to **Judi Tamasi, Paul Edelman - MRCA**  
from **Laurel Kelly**  
re **Review of MEHOA Parking Alternative at Lechuza Beach**  
date **4/30/10**

**Review of MEHOA Parking Alternative at Lechuza Beach**

# EAST SEA LEVEL DRIVE--REVISED MEHOA PLAN

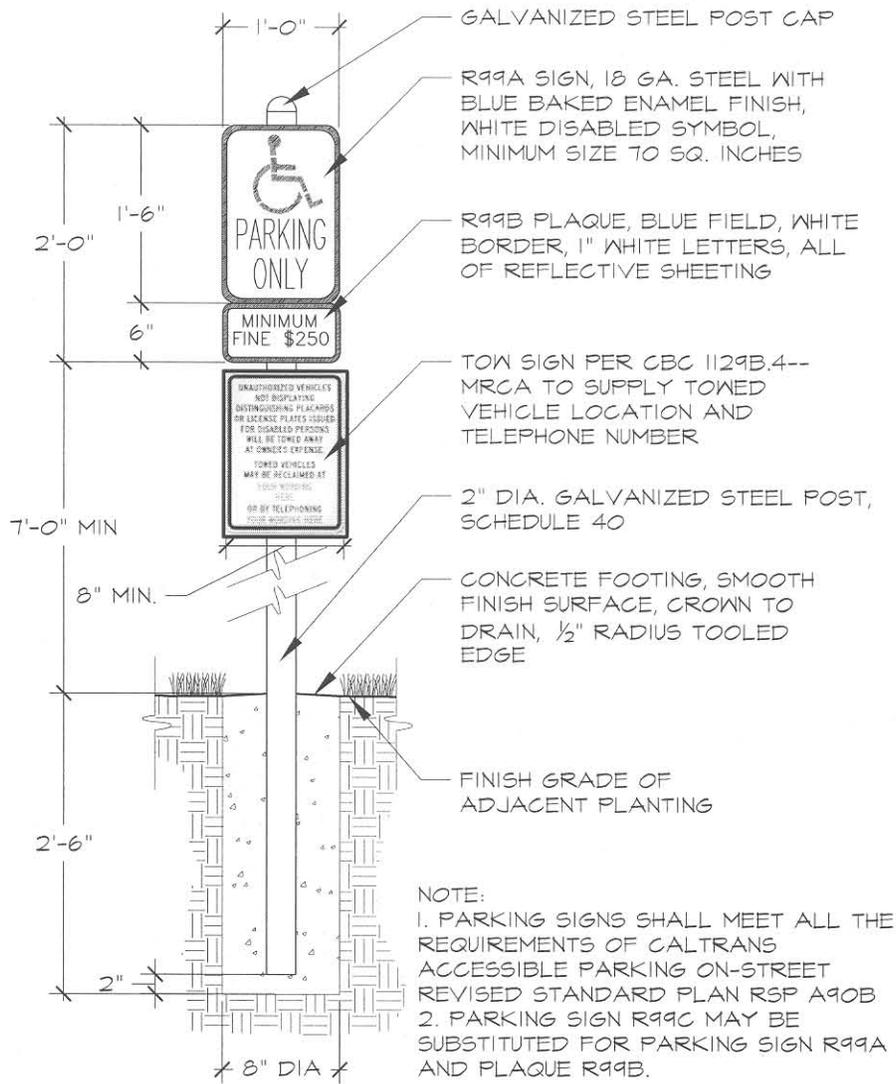
4. The distance from parking space #1 to the entrance at the public beach is approximately 170 linear feet. The distance from parking space #3 to the entrance at the public beach has grown to approximately 550 linear feet, which may be perceived as a barrier to access for people with mobility disabilities.

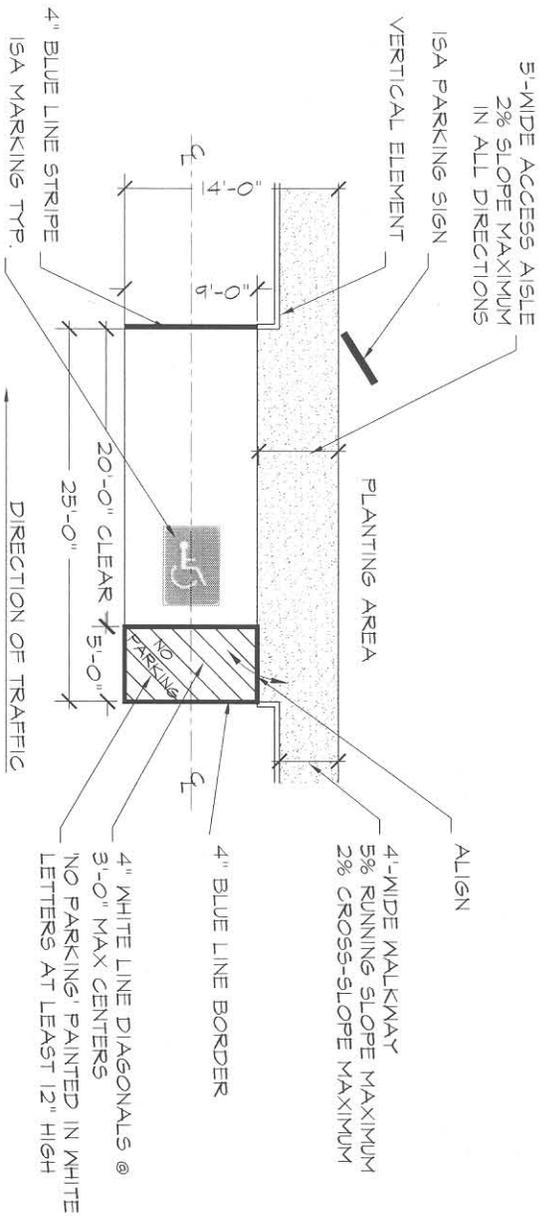
1. An accessible path of travel from the furthest parking space to the public entrance to Lechuza Beach is required. This feature was not included in MEHOA's alternative.
2. A 5-foot wide access aisle on the passenger side of each accessible parking space is also required. This feature was not included in MEHOA's alternative.
3. Some of the locations for parking spaces that were selected by MEHOA do not provide a 20-foot clearance between improvements on the north side of East Sea Level Drive and the edge of parking spaces. If these locations are ultimately chosen, some existing improvements (planting and retaining walls) will need to be removed in order to meet the requirements of the local fire department.
